FARRAGUT VISUAL RESOURCES REVIEW BOARD AGENDA

Farragut Town Hall
Board Room
Tuesday, November 28, 2023
7:00 p.m.

TO: Farragut Visual Resources Review Board
FROM: Bart Hose, Assist. Community Development Director
SUBJECT: Regularly Scheduled Meeting - Tuesday, November 28, 2023, at 7:00 p.m.

FILE: Pals Auto Monument West Knox

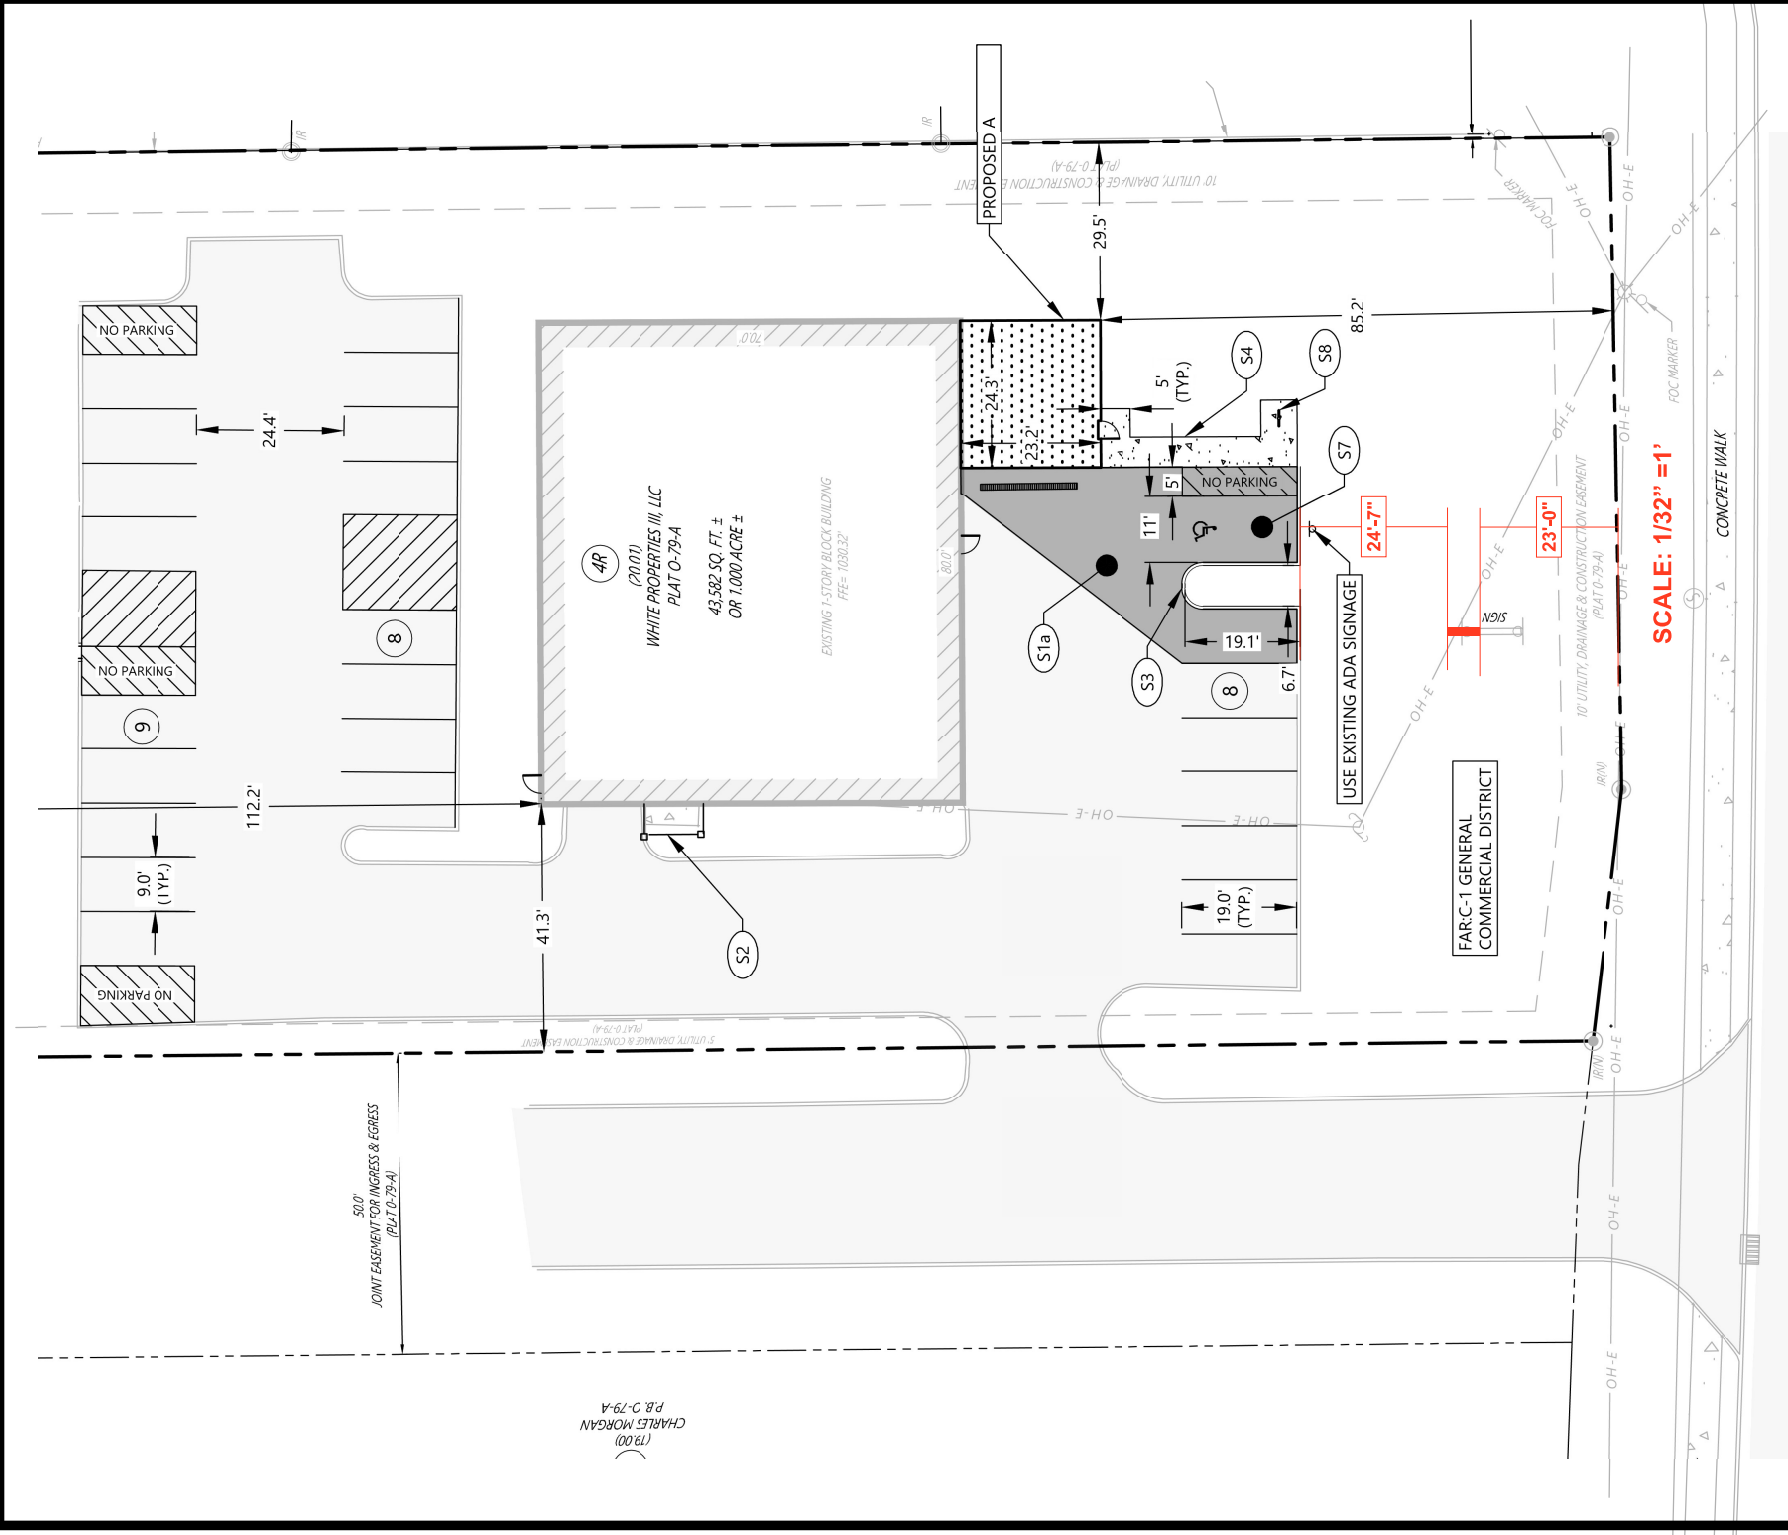
The application involves a new approximately 31 square foot monument sign for PALS Automotive Repair. The applicants will be remodeling the existing structure and have recently reviewed plan approval from the Planning Commission. Staff recommends approval of the sign subject to the following:

1. The sign base being made to be architecturally compatible with the principal material being used on the remodeled building façade. If this case, the base will need to be made of or faced with brick to match the front of the building.
2. The landscape plan will need to be revised to clearly identify the number, type, and arrangement of the proposed plantings within the required 50 square foot area around the sign base.

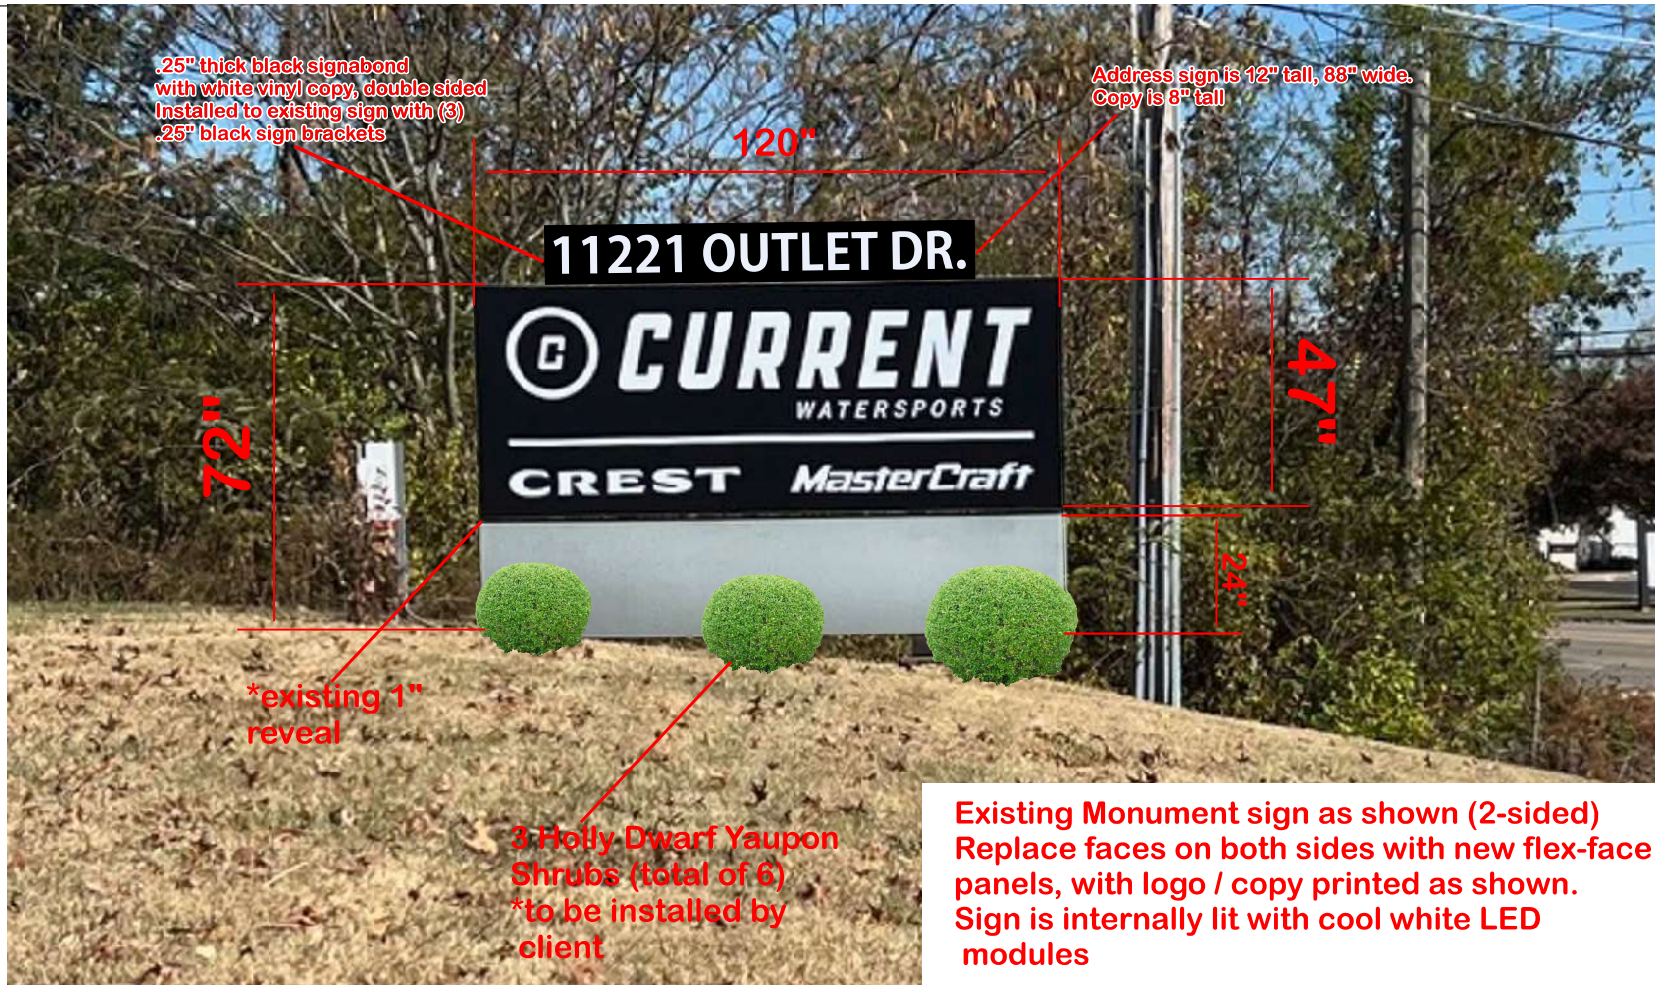
The application involves a 32 square foot existing monument sign for Hearthside Bank. The sign is being refaced, the sign cabinet is being painted, and the existing brick sign base will be painted to match the recently remodeled building. Staff recommends approval of the sign subject to the following:

1. The landscape plan will need to be revised to clearly identify the number, type, and arrangement of the proposed plantings within the required 50 square foot area around the sign base. This landscaping should be coordinated with the larger landscaping plan for the overall site.

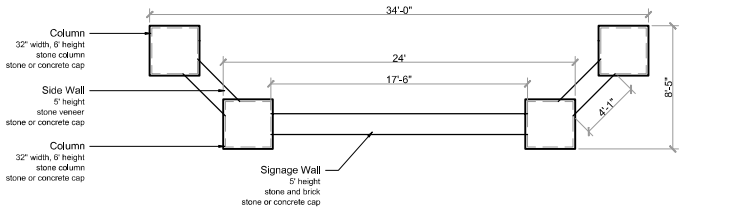
This application involves refacing an existing 39 square foot monument sign for Current Watersports. The applicants will also be reestablishing compliant landscaping as part of the request. The staff recommends approval of the sign subject to the following:

1. Raising the grade around the front portion of the sign and ensuring that the landscape improvements surround the existing base and conceal the visible sign supports.

Entry Sign - Layout and Landscape Plan

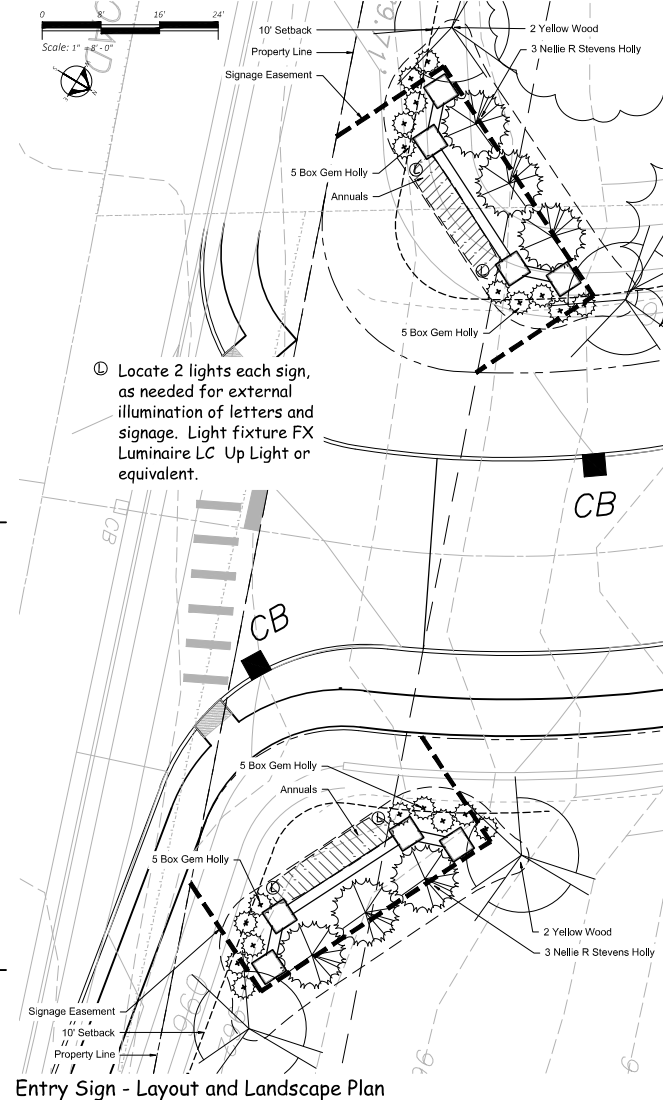
The application involves two twenty square foot subdivision entrance signs for Grigsby Park Development. The proposed signs will be mounted on decorative wall features on both sides of the subdivision entrance road. A total of 40 square feet of signage is permitted for a subdivision sign and the developer is allowed to split it between two signs as proposed. The staff recommends approval subject to the following:

1. Providing specifications and a detail confirming the construction/material for the sign face inset. The applicants have indicated that it will be a sandstone inset panel with black lettering. This needs to be confirmed for the permit.

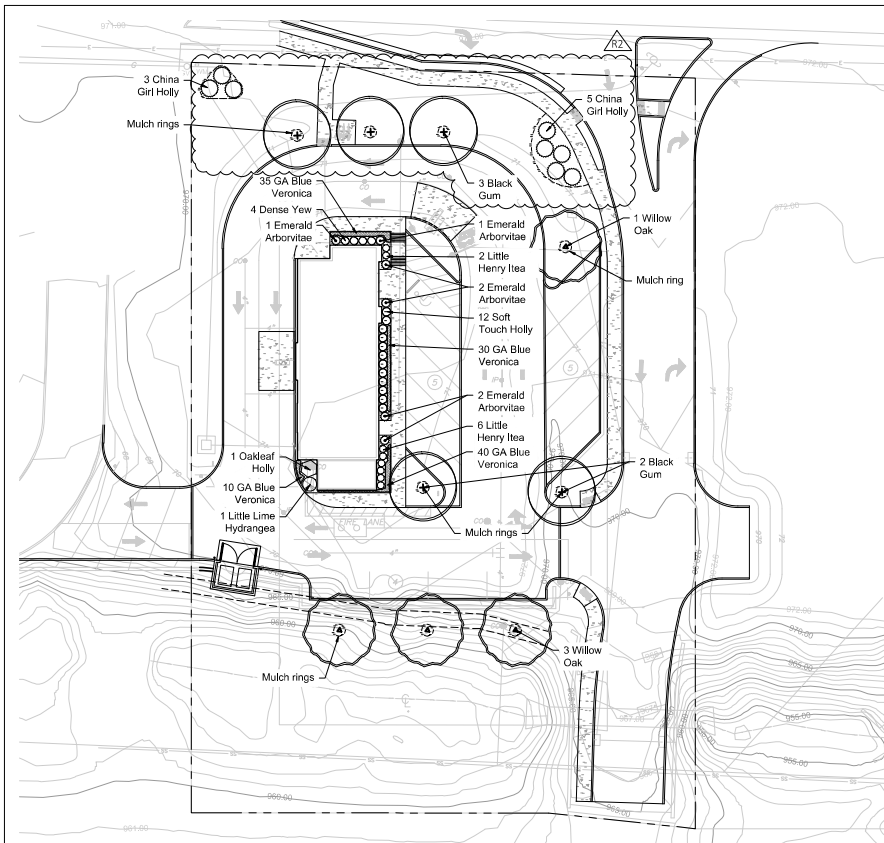
The plan includes required landscape elements for shade trees, parking lot screening, and landscaping around the buildings. The staff recommends approval subject to the following:

1. The addition of some additional plantings to better screen the drive-through lane and parking lot traffic lanes between the front of the building and Kingston Pike.
